Side Blinker Lamp body crack

Implementation

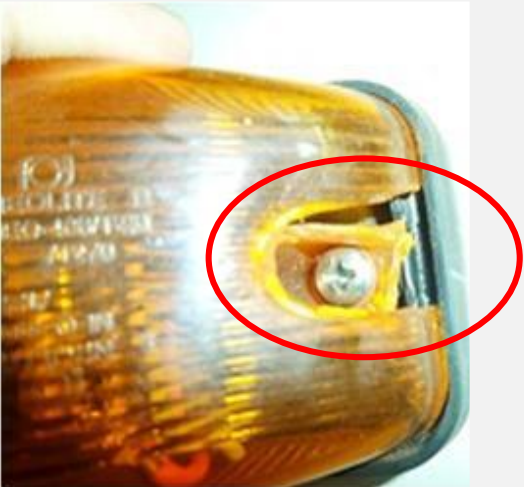
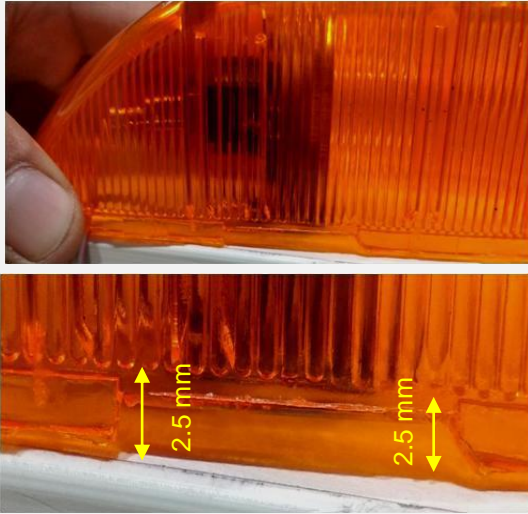
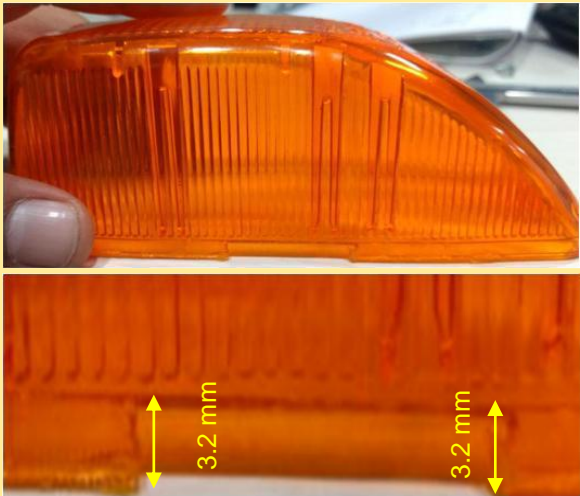
Defect Description	Side Blinker Lamp body crack near mounting screw.
Corrective action taken	<ul style="list-style-type: none">• Lens slot depth increased from 2.5 to 3.2 mm as per drawing to avoid the stress on lens after fitment on vehicle.• Radius provided inside the mounting lug to improve strength.
VIN cut-off	MBKMC5BE9JN020447
Cut-off date	Feb 2018
Vehicle models applicable	All CLA Trucks (Domestic)
Aggregate Sl. nr./ Batch code	X
DMN Nr.	X
Technical Information(s)	X

Old part(s) / Before implementation			New part(s) / After implementation		
Part Nr.	Part Description	Supplier	Part Nr.	Part Description	Supplier
64.25320-6007 /6008	INDICATOR LH/RH WITH BULB	Neolite ZKW Lightings Pvt. Ltd.	64.25320-6007 /6008	INDICATOR LH/RH WITH BULB	Neolite ZKW Lightings Pvt. Ltd.
			 <p>Radius provided</p>

Dust cloud formation

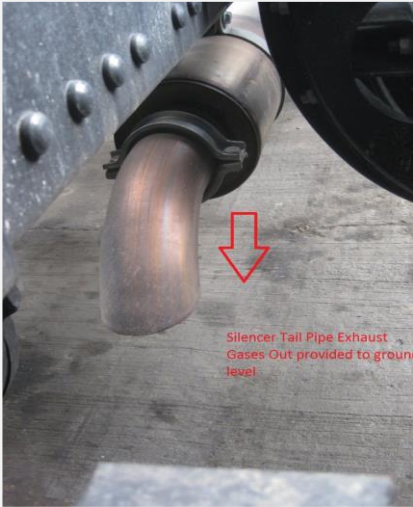
Defect Description	Dust cloud formation due to inappropriate Tail pipe orientation in BS IV haulage vehicles.
Corrective action taken	Changed orientation of tail pipe towards vehicle center line by 30 Deg.
VIN cut-off	MBKMC5AL3JN020377
Cut-off date	Jan 2018
Vehicle models applicable	All CLA BS IV Haulage Vehicles
Aggregate Sl. nr./ Batch code	X
DMN Nr.	15126
Technical Information(s)	X

Old part(s) / Before implementation			New part(s) / After implementation		
Part Nr.	Part Description	Supplier	Part Nr.	Part Description	Supplier
NA	Exhaust Tail Pipe	M/s Diversitech	NA	Exhaust Tail Pipe	M/s Diversitech
 <p>Silencer Tail Pipe Exhaust Gases Out provided to ground level</p>			 <p>30° deg</p>

Identification criteria for new part(s)/ assy.	X
Service Document(s)	In case of any customer complaint of dust cloud formation, change orientation of tail pipe towards vehicle center line by 30°.
Retro-fitment in Plant & BSR	X
Retro-fitment in Field	X
Warranty labour rate	X
MAN Defect Codes	X

AC Pulley shaft and bearing failure in Bus

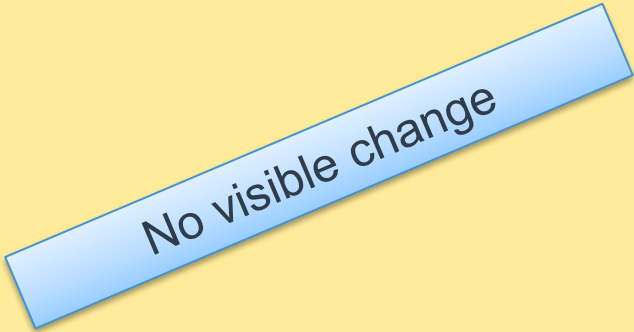
Defect Description	AC Pulley shaft and bearing failure
Corrective action taken	Fitment process is improved by ensuring proper alignment of shaft with AC pulley & bearing while press fitting with the help of newly developed fixture.
VIN cut-off	MBKMF5AA8JN000213
Cut-off date	Jan 2018
Vehicle models applicable	CLA Buses
Aggregate Sl. nr./ Batch code	X
DMN Nr.	X
Technical Information(s)	X
